Application for resource consent or fast-track resource consent

**Application for Change and Cancellation of
Conditions of RC 2250212 -RMALUC**
(Under 127 of the RMA)

In December 2024, the applicant, Tiopira Taniera Hapu Trust (or the Trust) obtained a resource consent (Ref: RC 2250212-RMALUC) to establish an aged care and retirement village facility on the property at 52 Hooks and Hall Road in Waimamaku. Copies of the RC decision and approved plans are attached in **Appendix 1**.

Therefore, on behalf of the applicant, I request changes to Condition 1 of RC 2250215, particularly the references to the approved plans and technical reports, and consequent amendments to other conditions as described below, pursuant to Section 127 of the Resource Management Act.

Figure 1

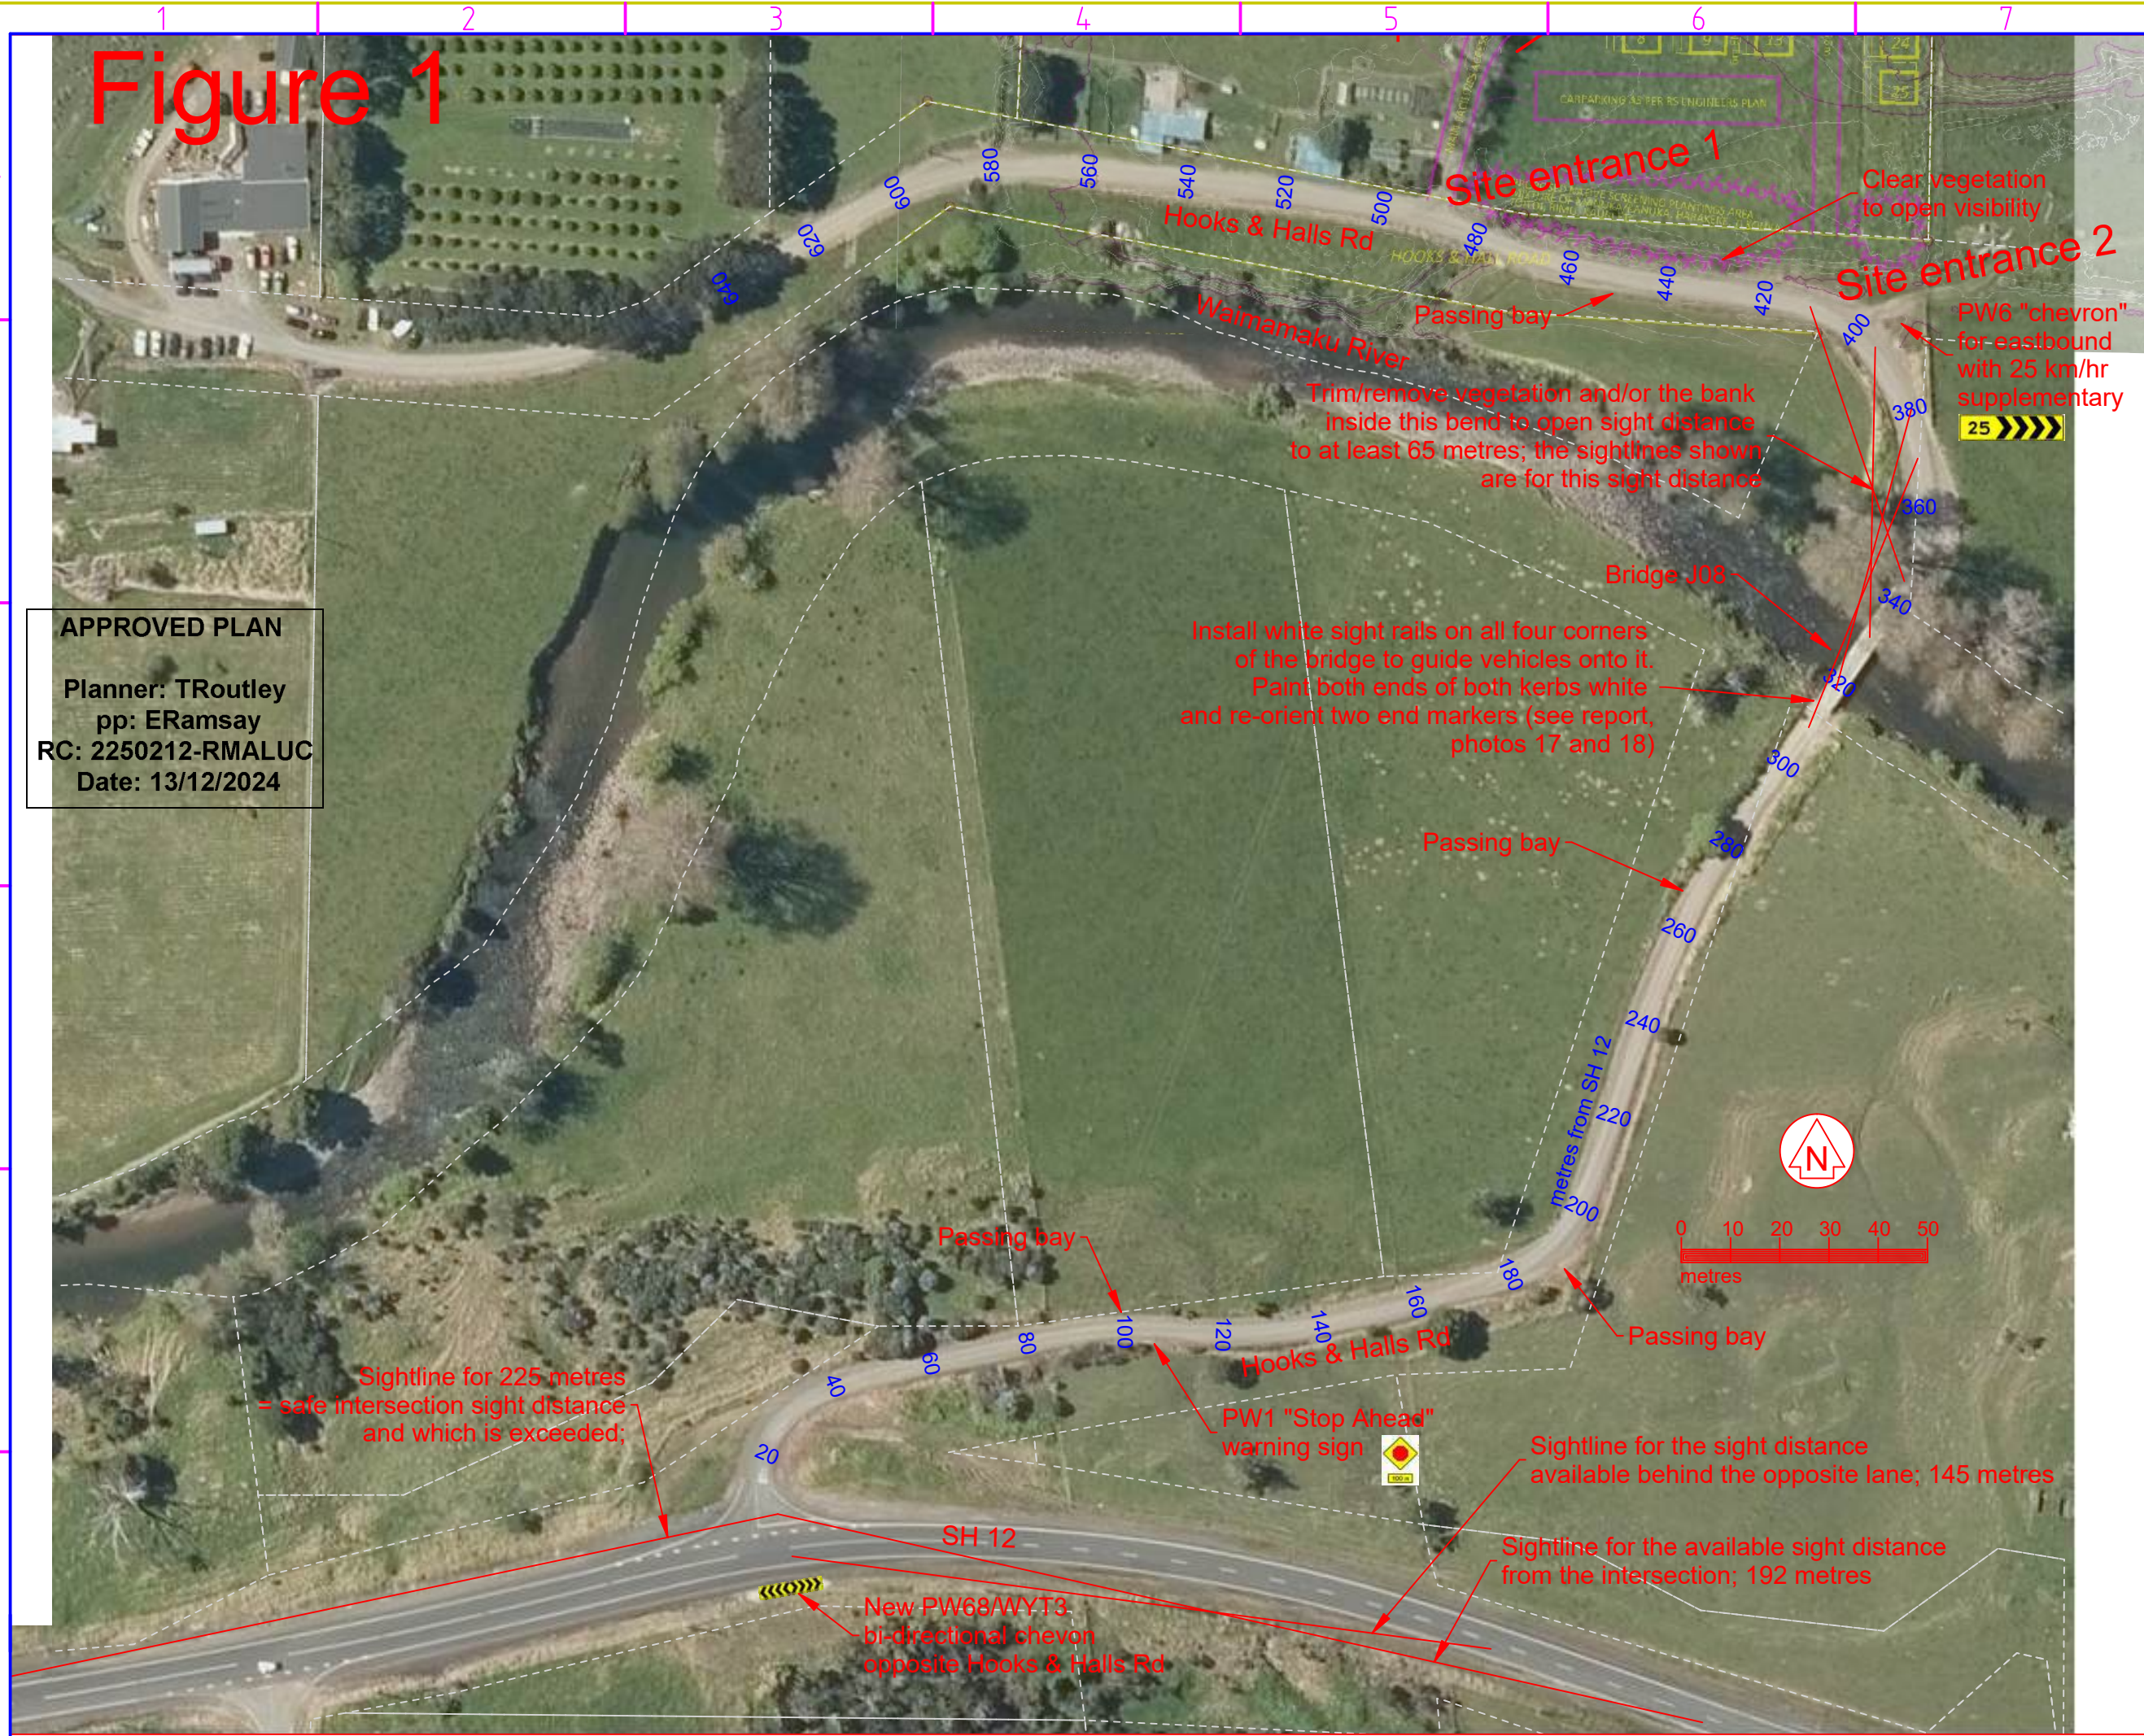
Engineering Outcomes plan titled 'Figure 1 Hooks and Hal Road Safety Measures Plan' is dated ~~5~~ 3 December 2024, and not 5 December 2024, as referenced in this condition. This typological error needs to be corrected.

- Engineering Outcomes, titled 'Retirement and Elder Care Assessment of Traffic Effects Report, dated 3 December 2024, and
 - Engineering Outcomes, titled 'Figure 1 Hooks and Hall Road Safety Measures Plan', dated ~~5~~ 3 December 2024, and

Figure 2

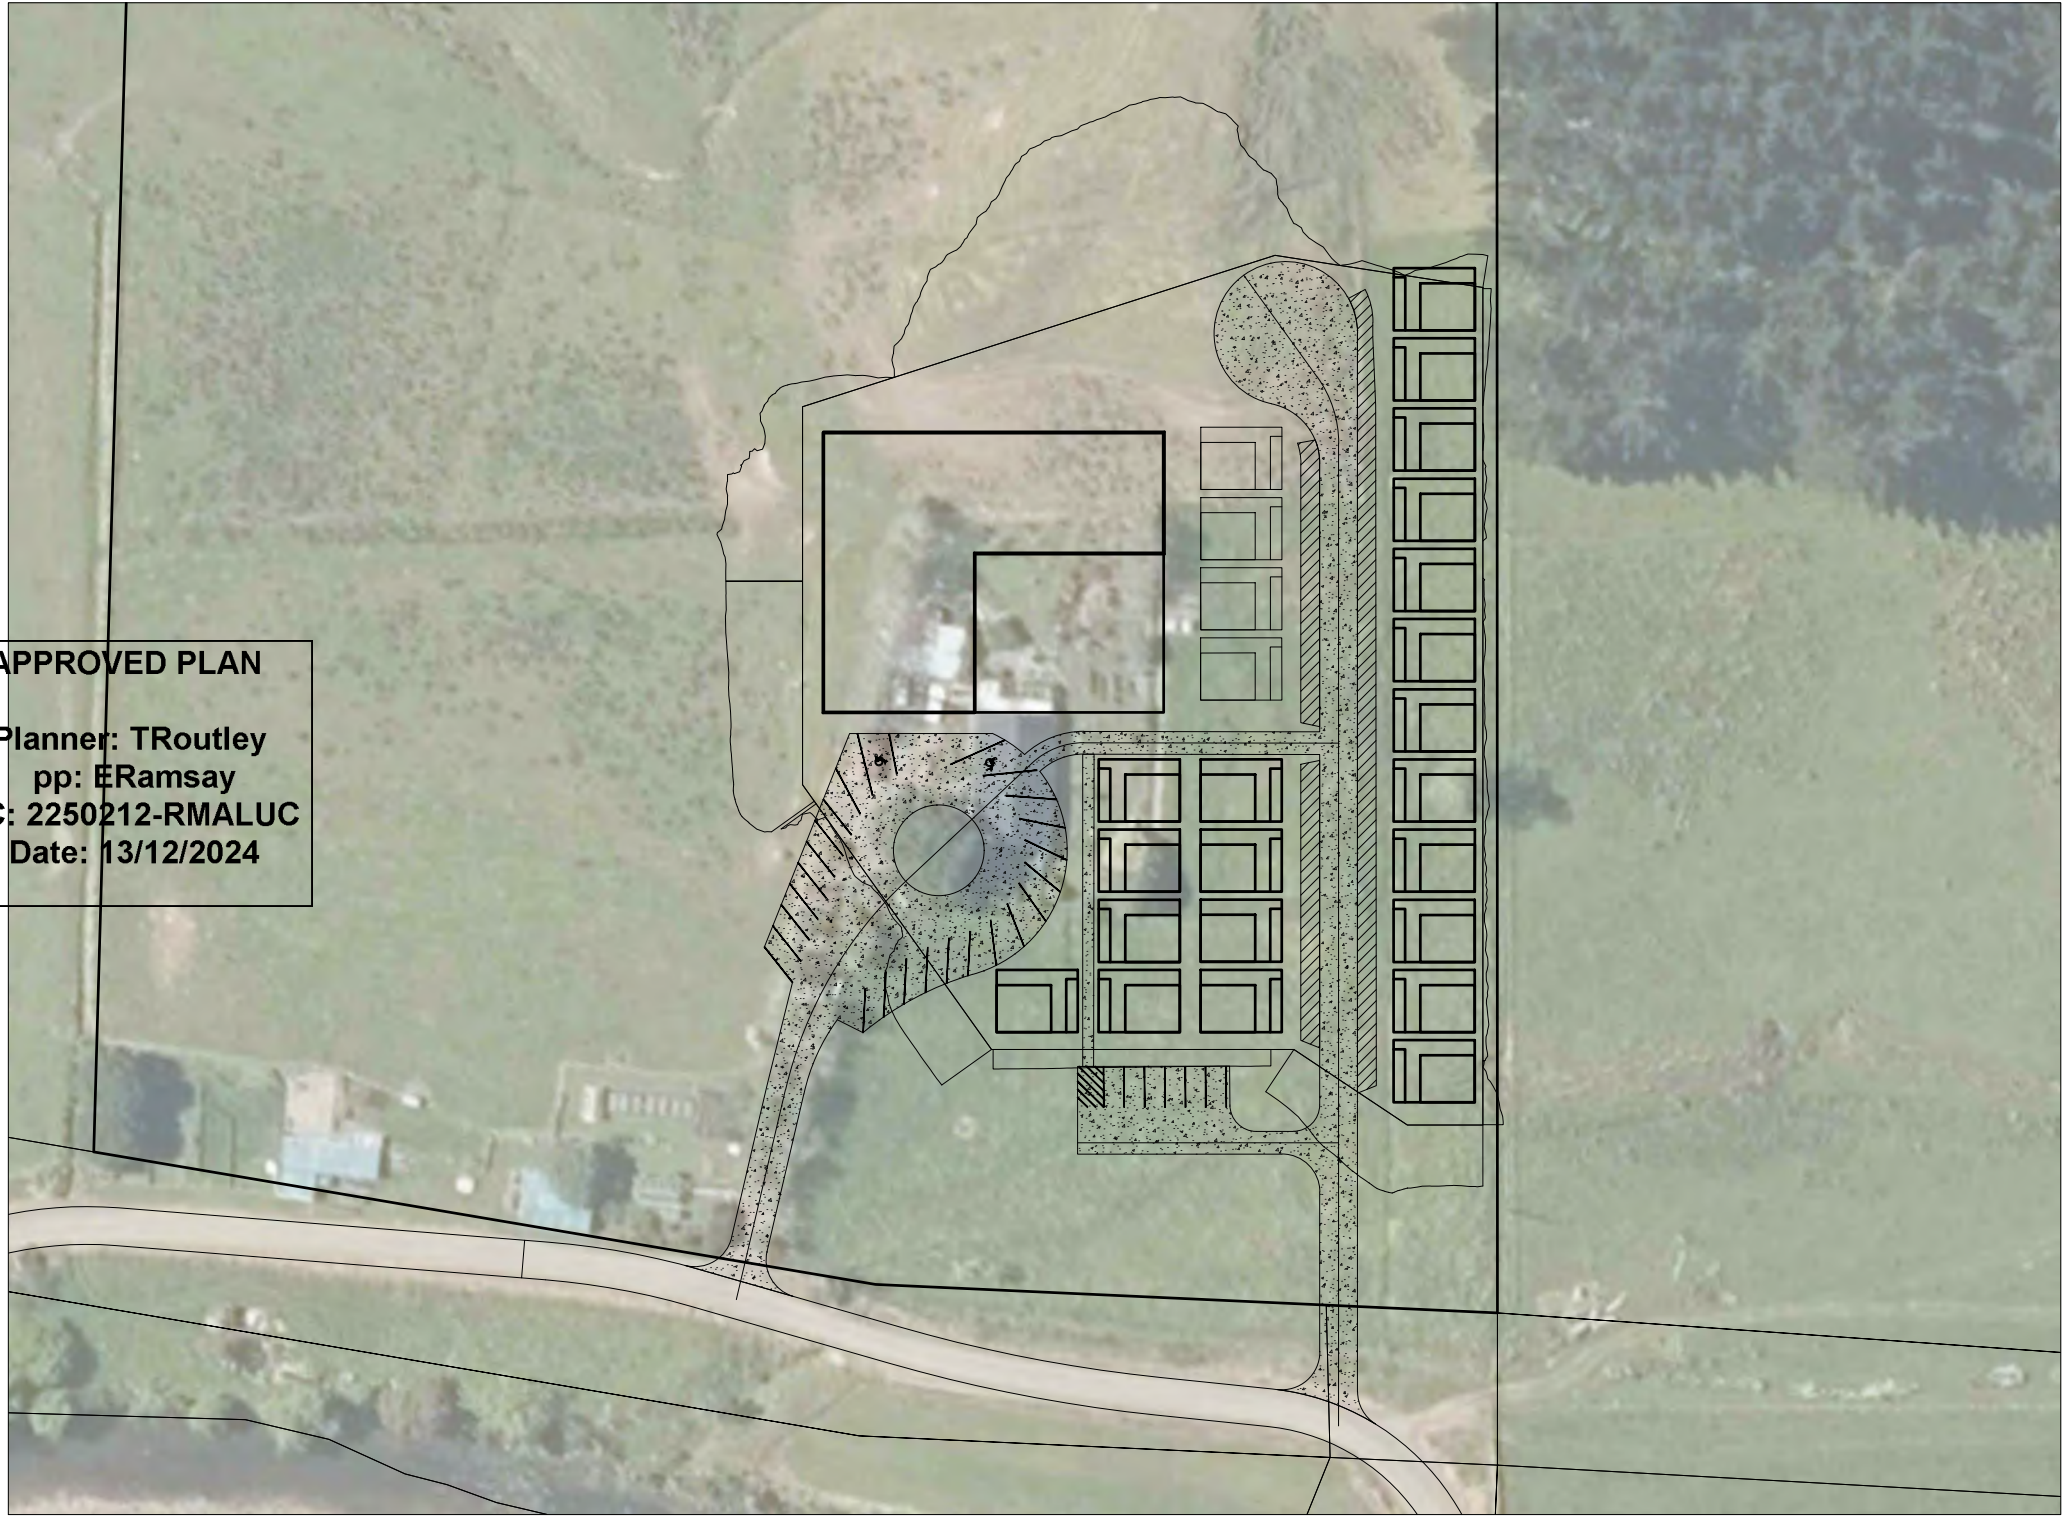
Engineering Outcomes plan titled 'Figure 2 Parking Internal Plan' is no longer relevant for this consent. That reference needs to be cancelled.

- ~~Engineering Outcomes, titled 'Figure 2 Parking Internal Plan', dated 3 December 2024, and~~

SITE MASTERPLAN

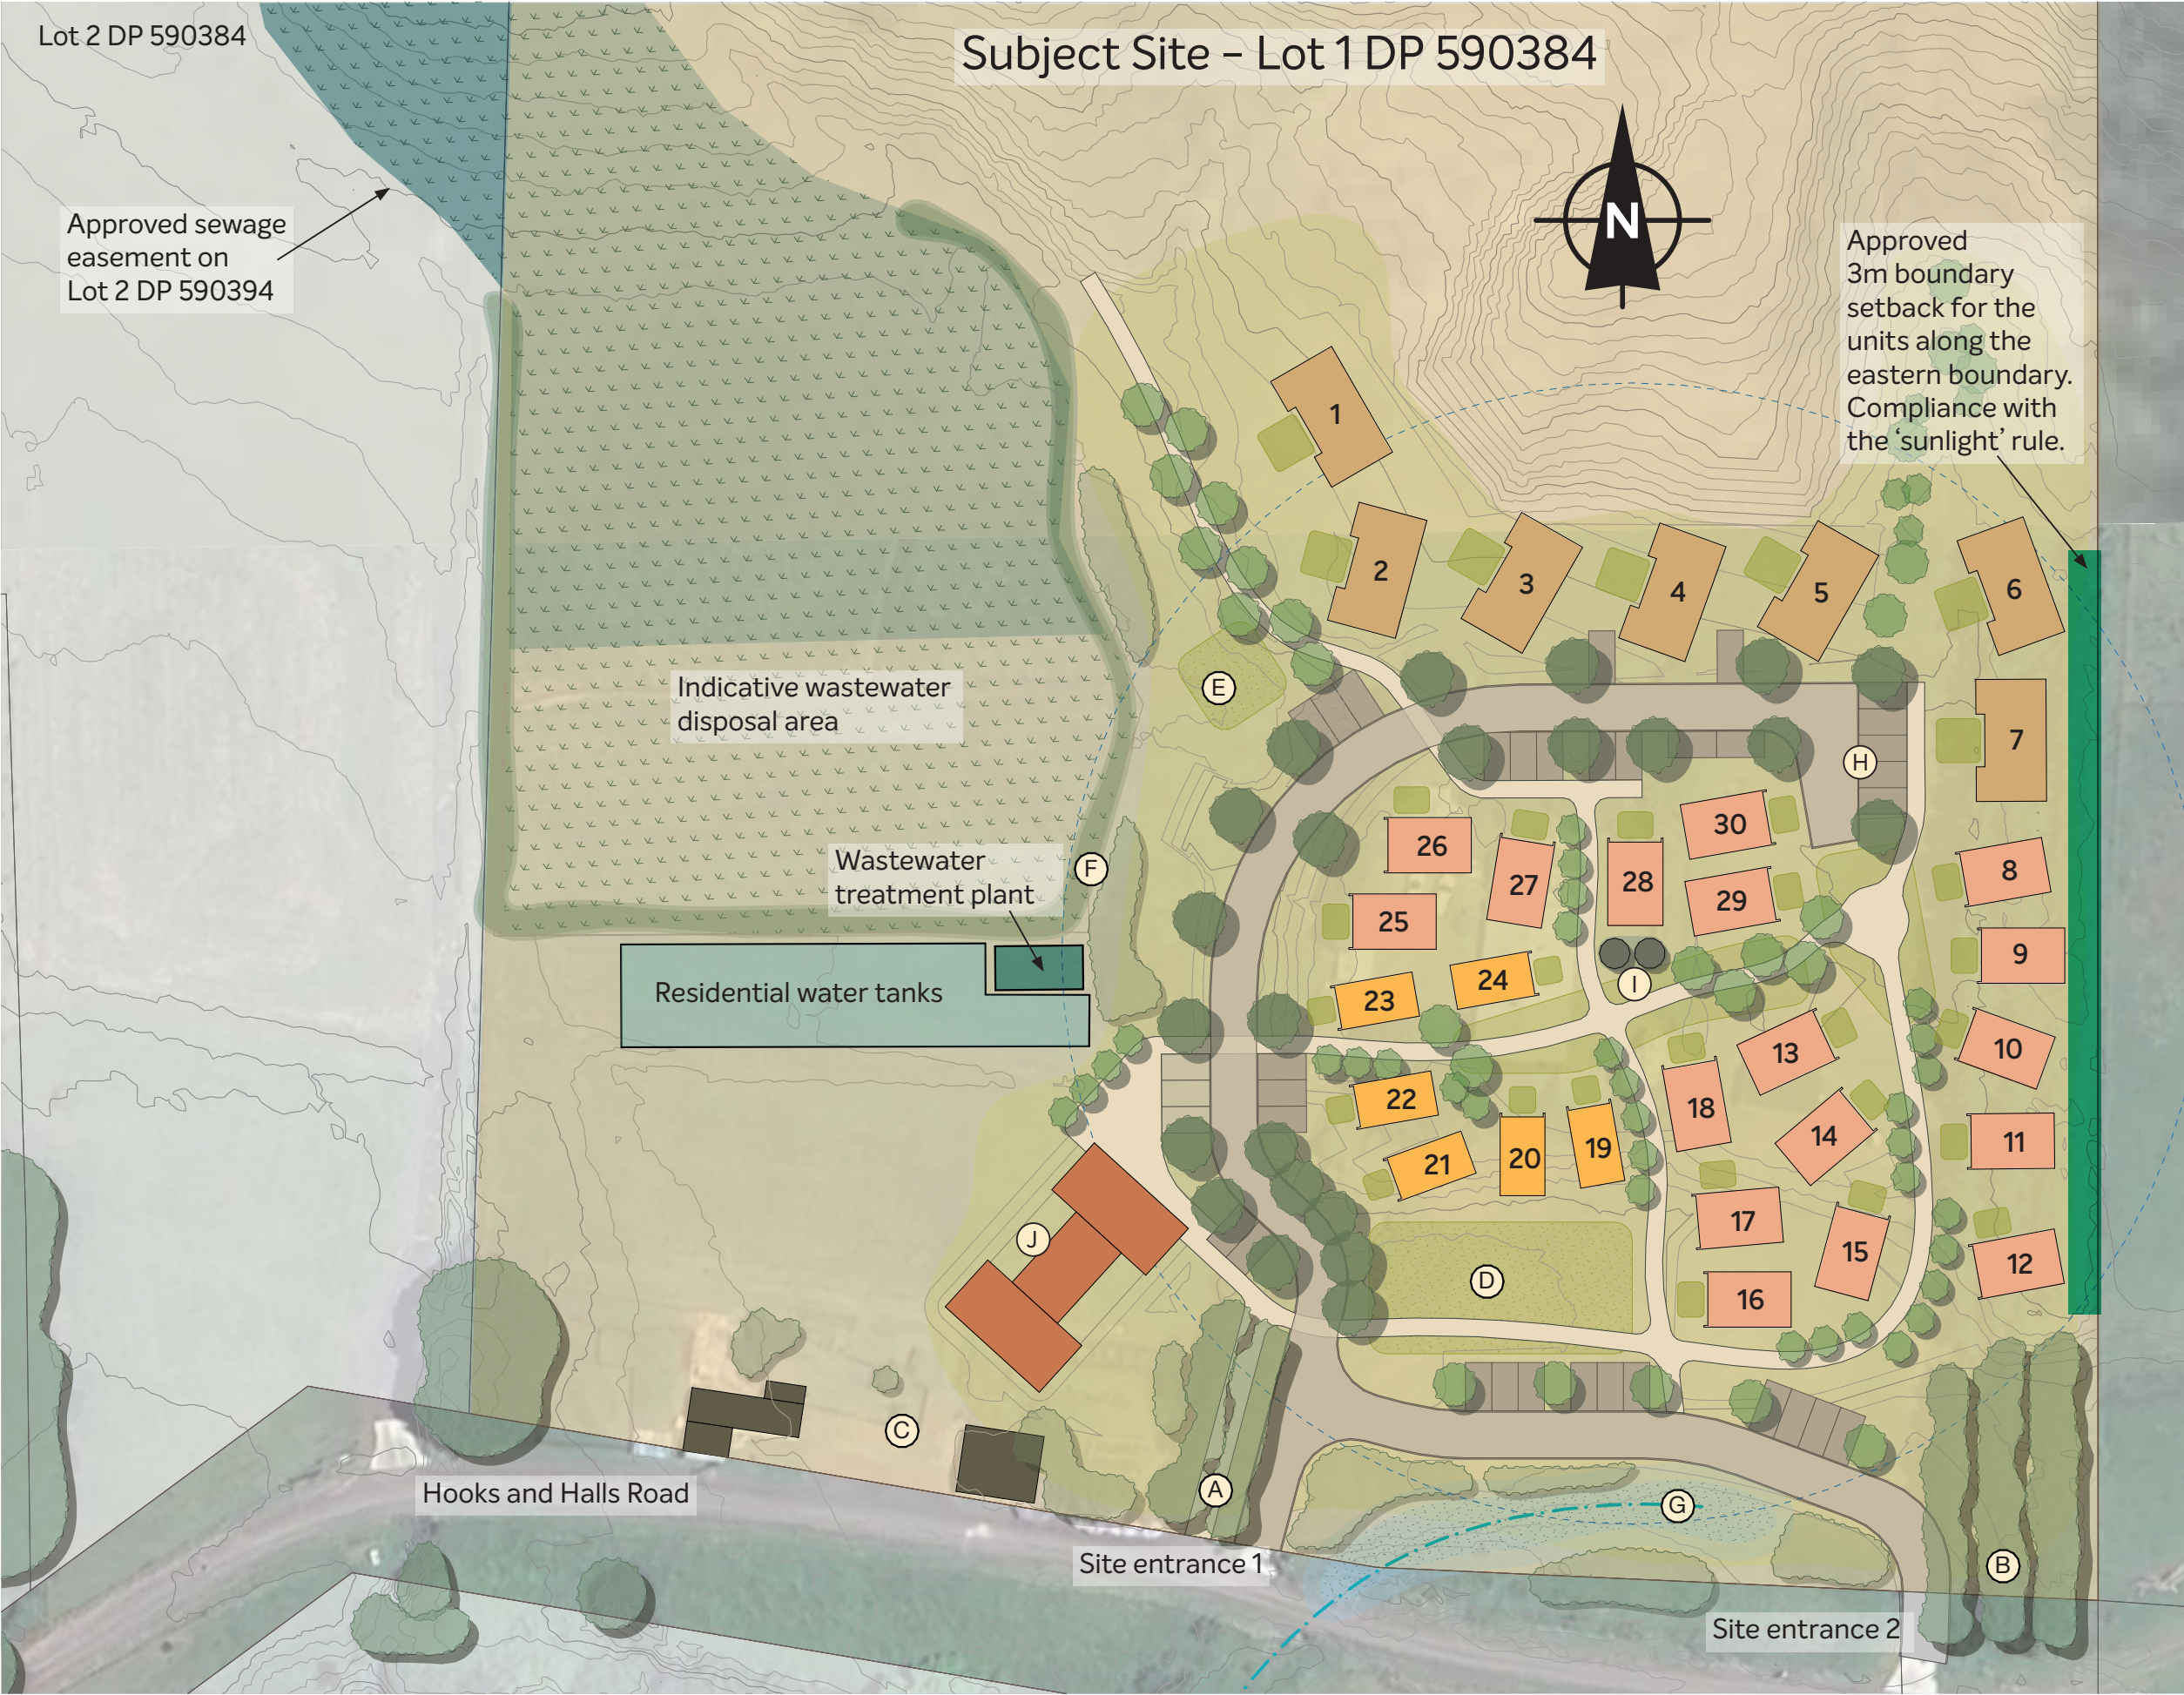
A copy of the revised Site Masterplan prepared by WEIR + is attached in **Appendix 3**.

The Site Plan and RS Eng's three technical reports referenced in this condition have been amended or updated to suit the revised proposal. The Concept Civil Drawings submitted as a separate report in the original application are now included as Appendix 6 in the Three Waters Report. Thus, the condition should refer to the updated 'site masterplan' and reports submitted with this application.

- WEIR + , referenced 'Waimamaku Affordable and Kauatua Housing'- Site Masterplan, dated 01.04.2025, and
 - RS Eng, titled 'Geotechnical Investigation Report' referenced 19340 Rev-2 Rev 3, dated ~~11 November 2024~~, 11 April 2025, and
